LANDSCAPE AND VISUAL REBUTTAL

**OF BRIAN JOHN DENNEY BA (HONS), DIPLA, FLI, CENV,
MIEMA**

**AN OUTLINE PLANNING APPLICATION FOR THE
ERECTION OF UP TO 85 RESIDENTIAL DWELLINGS
(*REDUCED FROM 93 ORIGINALLY*) AND OPEN SPACE
(17/04673/OUT)**

**LAND AT JUNCTION WITH CARR ROAD, HOLLIN BUSK
LANE, SHEFFIELD, S36 1GH**

VIEW S5

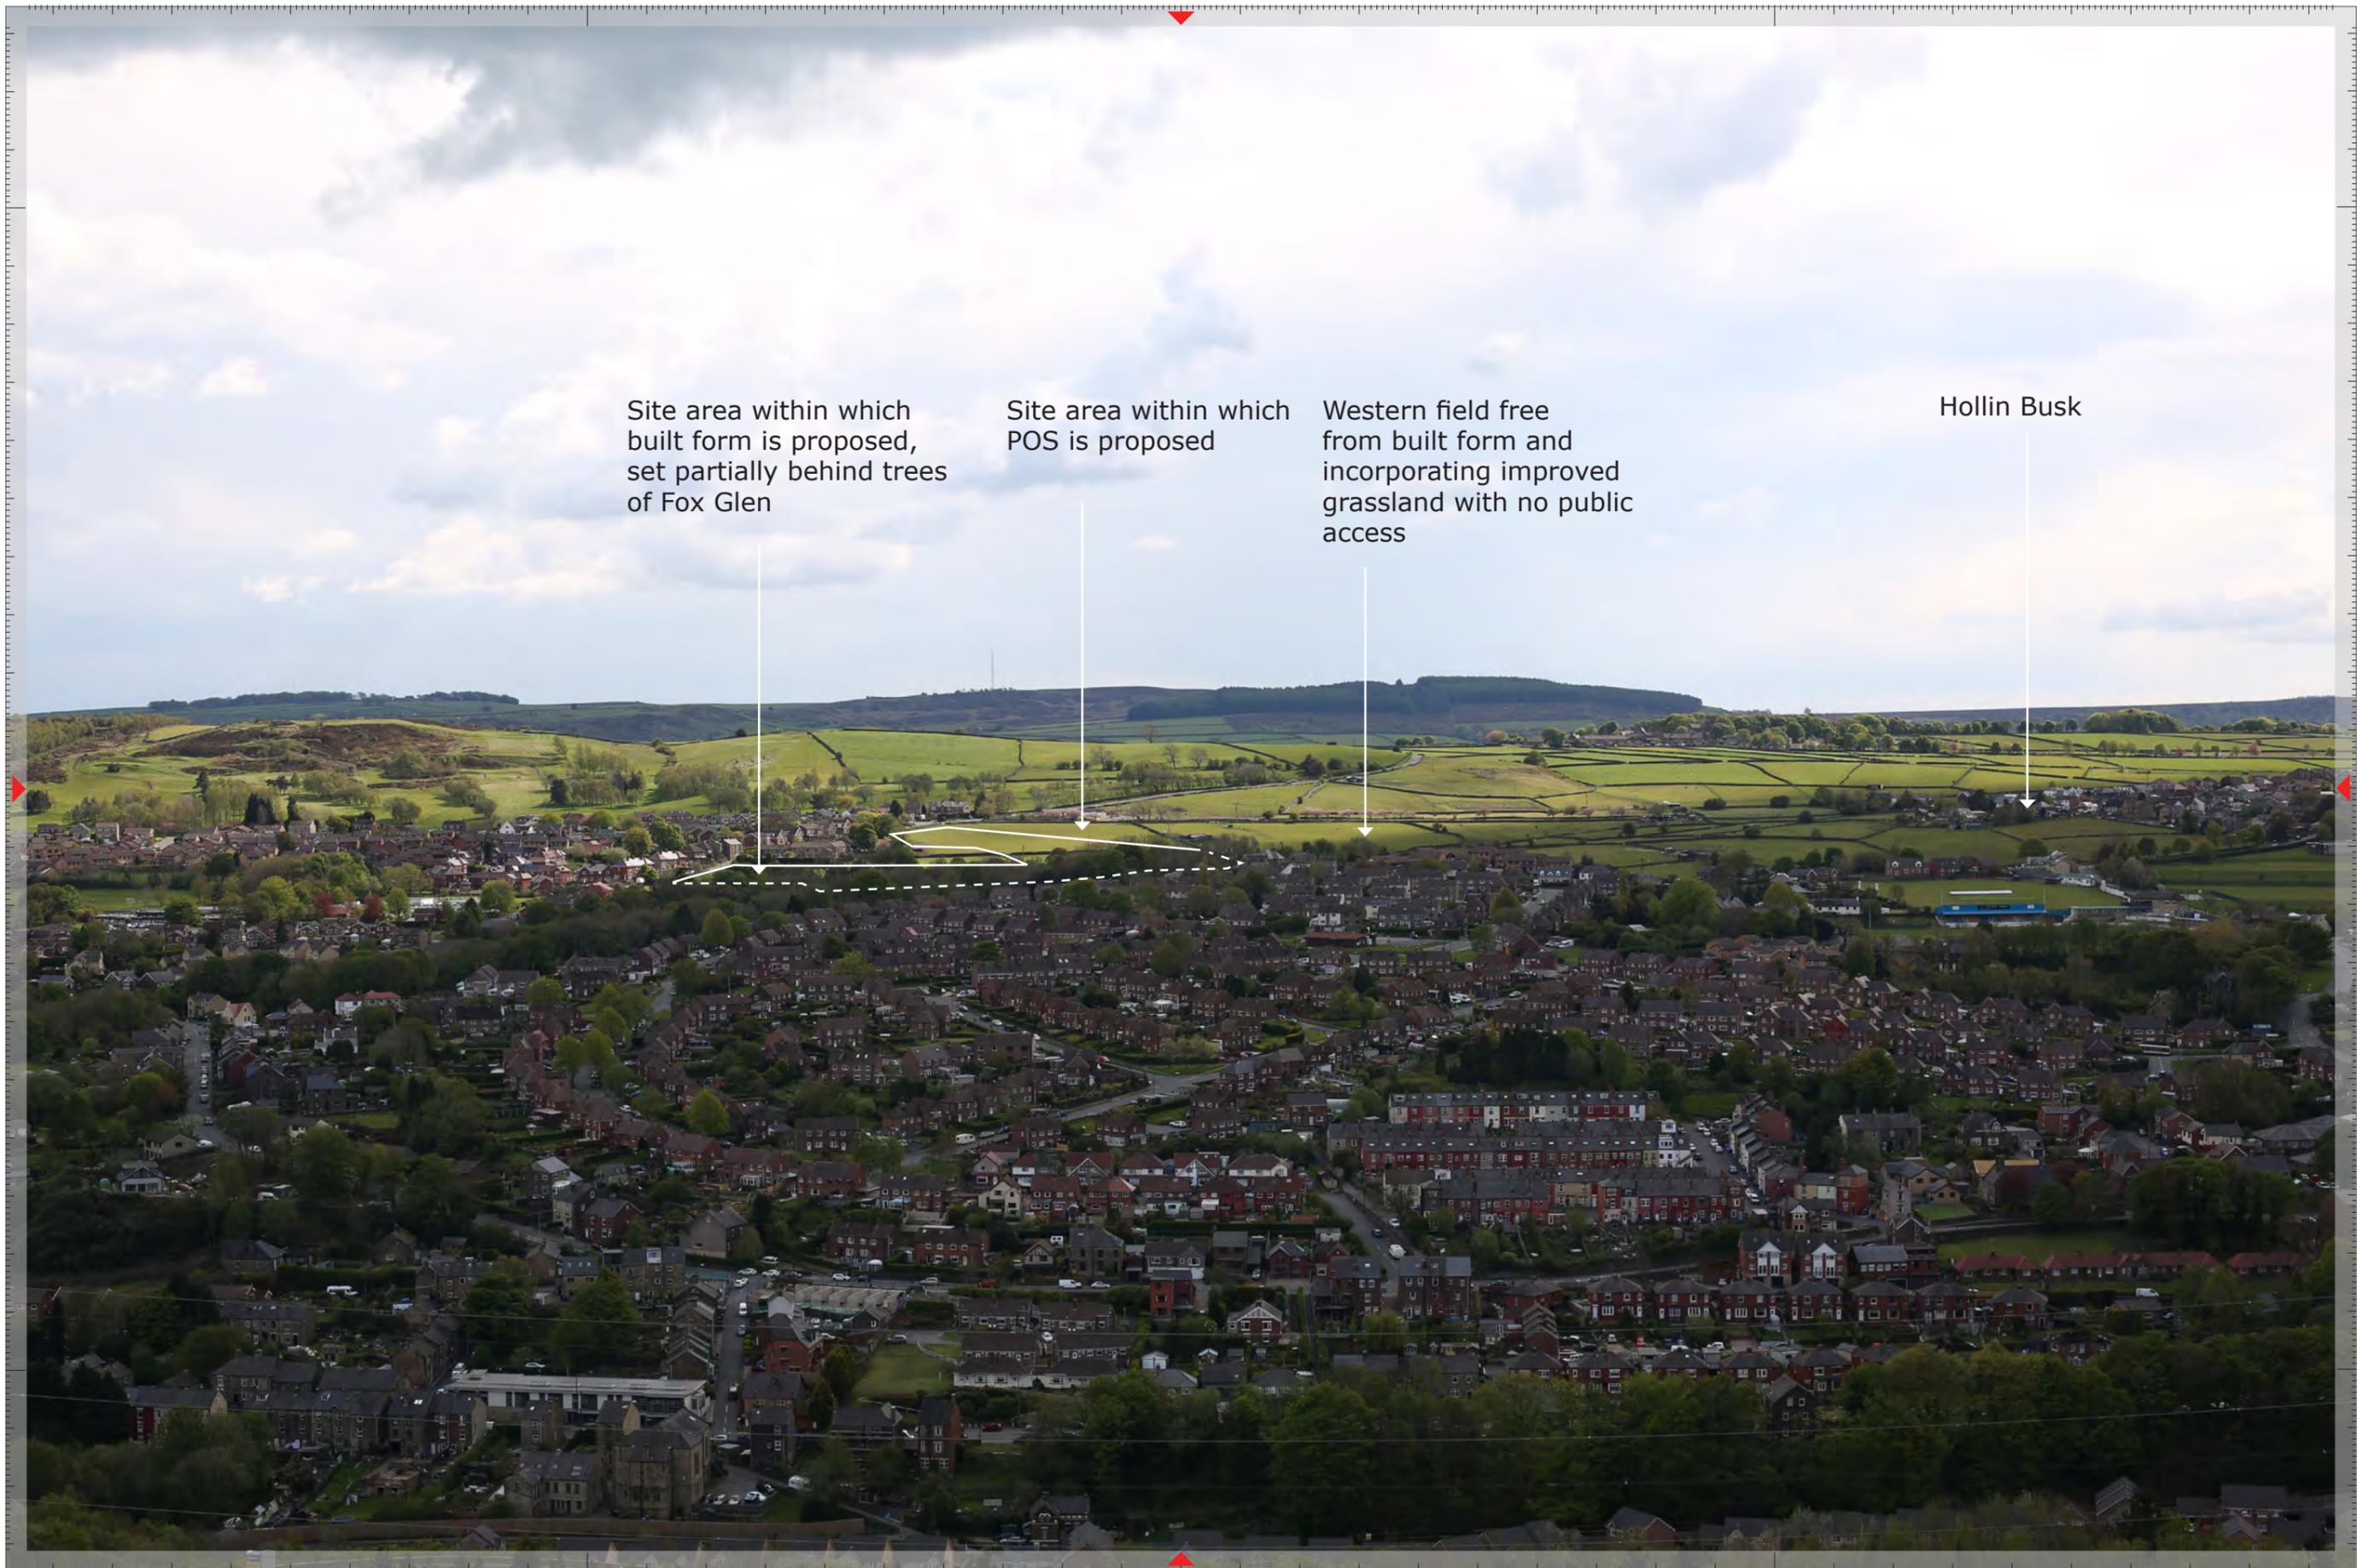
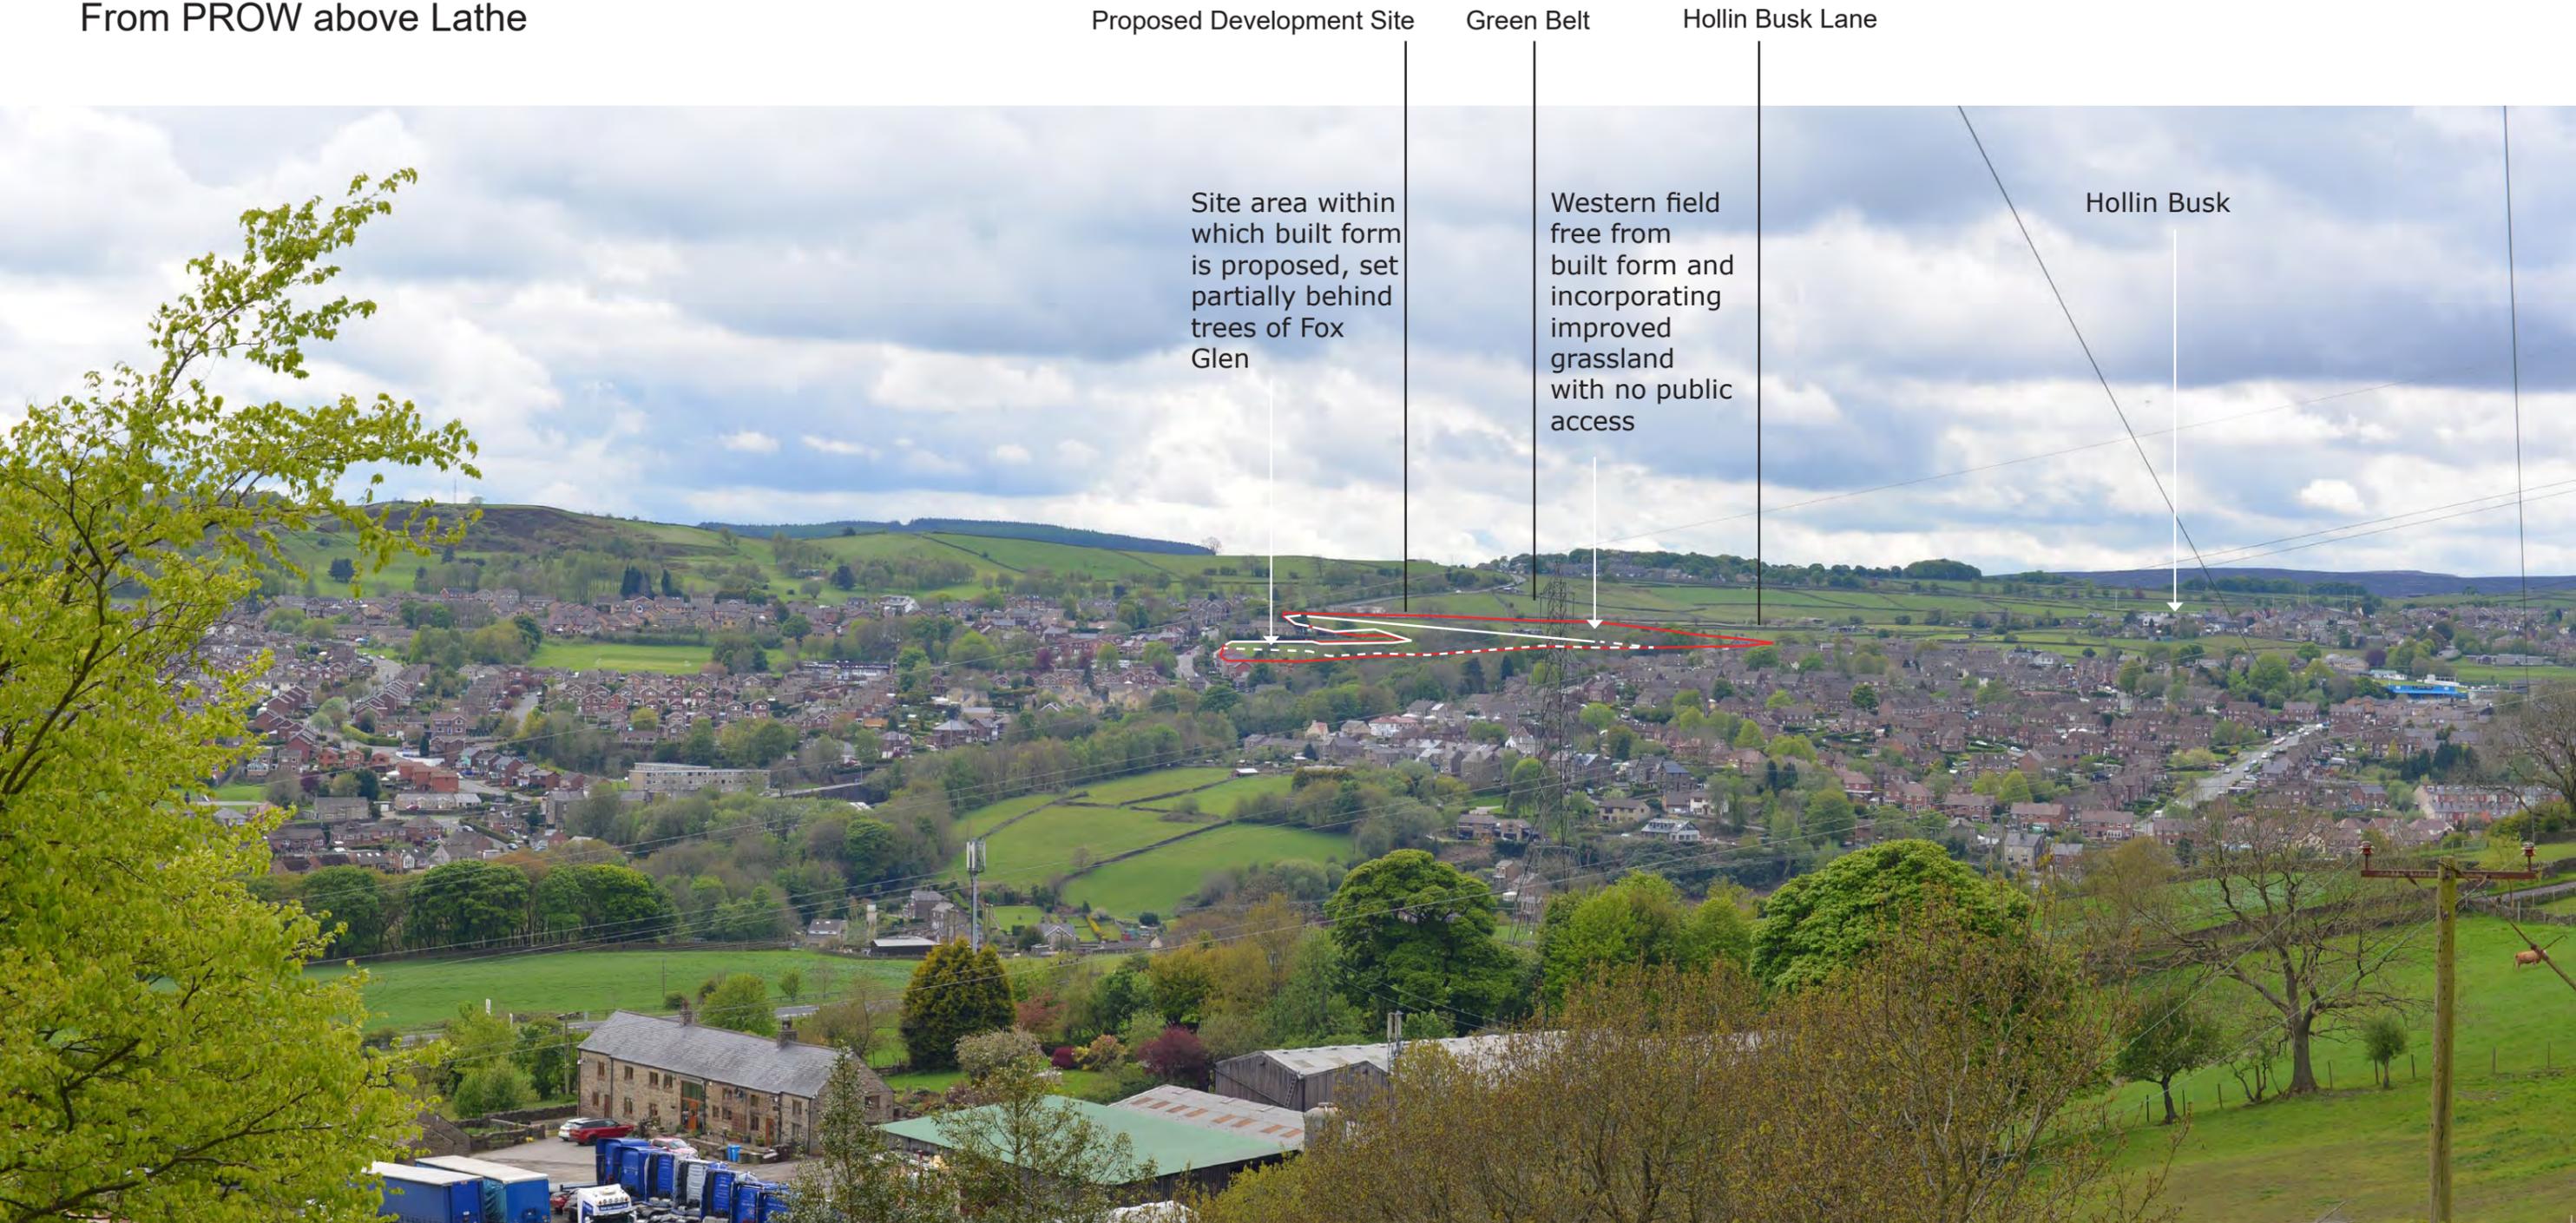
Above is Mr Ares' Photo from his viewpoint S5, to which I have added four annotations and a white outline of the area of proposed built form (dashed where set behind trees).

My photo from Mr Ares' viewpoint S5 with my annotations and a white outline of the area of proposed built form (dashed where set behind trees).

VIEW S6

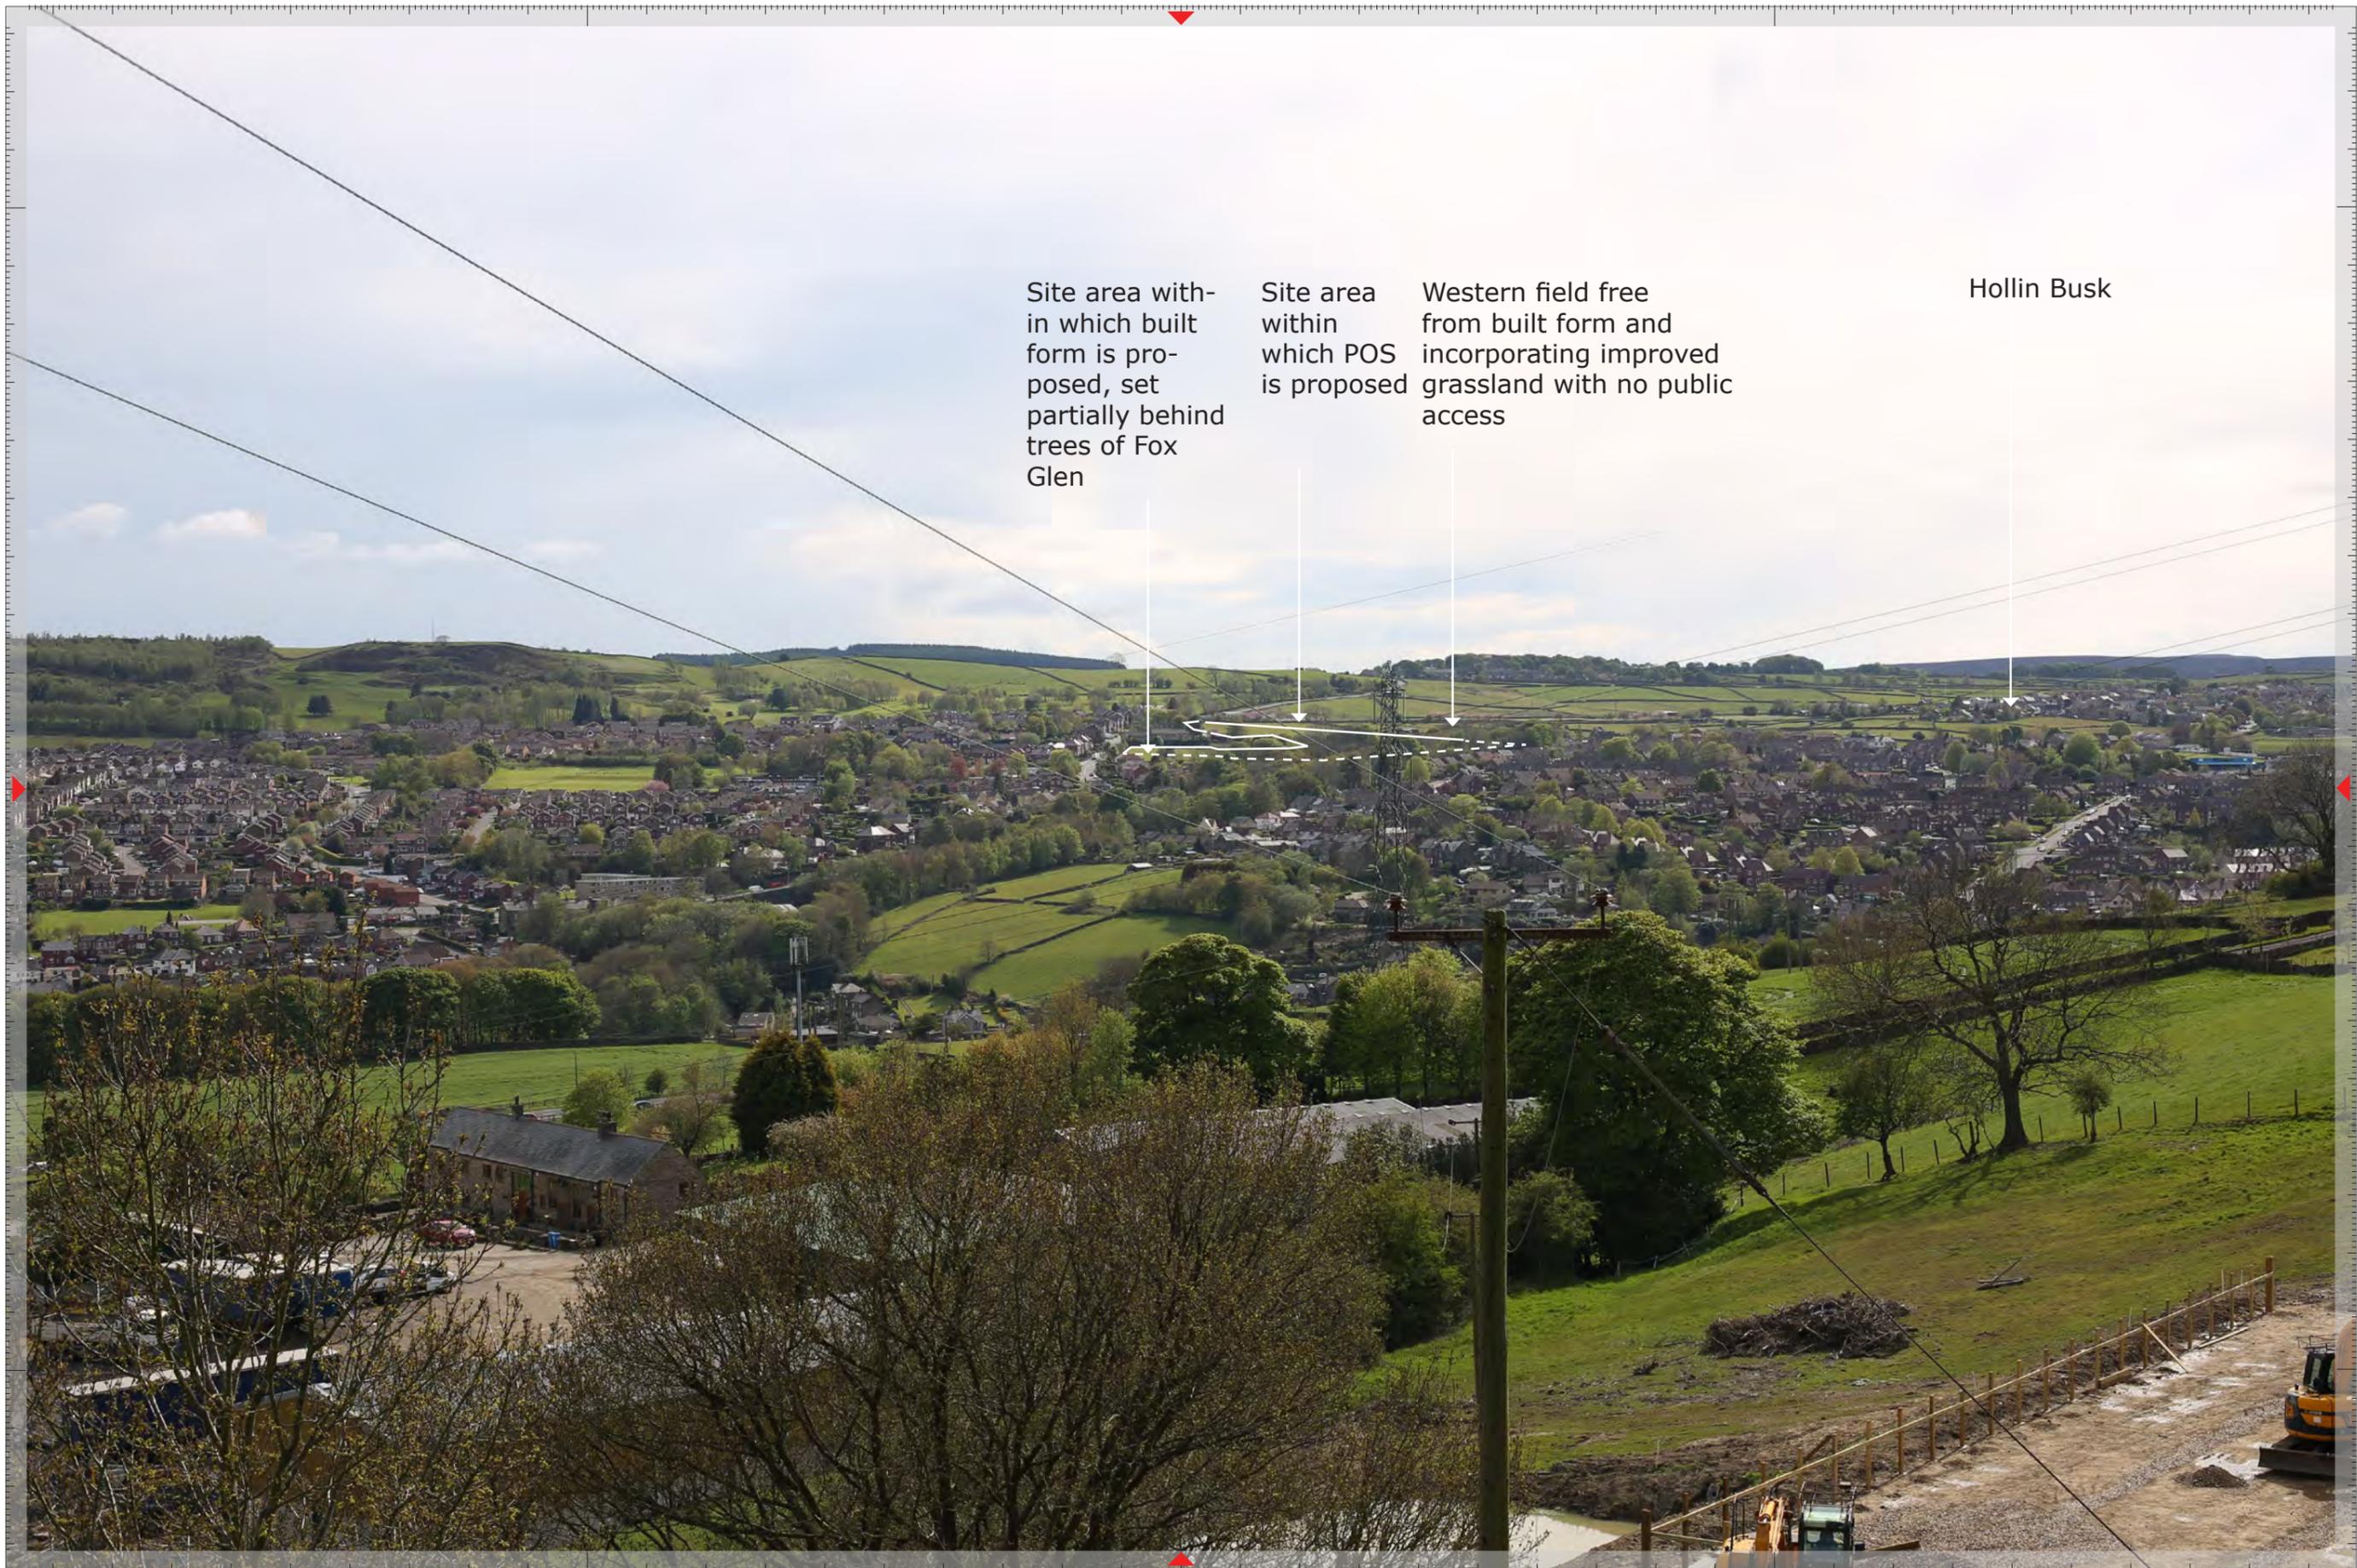
Above is Mr Ares' Photo from his viewpoint S6, to which I have added three annotations and a white outline of the area of proposed built form (dashed where set behind trees).

My photo from Mr Ares' viewpoint S6 with my annotations and a white outline of the area of proposed built form (dashed where set behind trees).
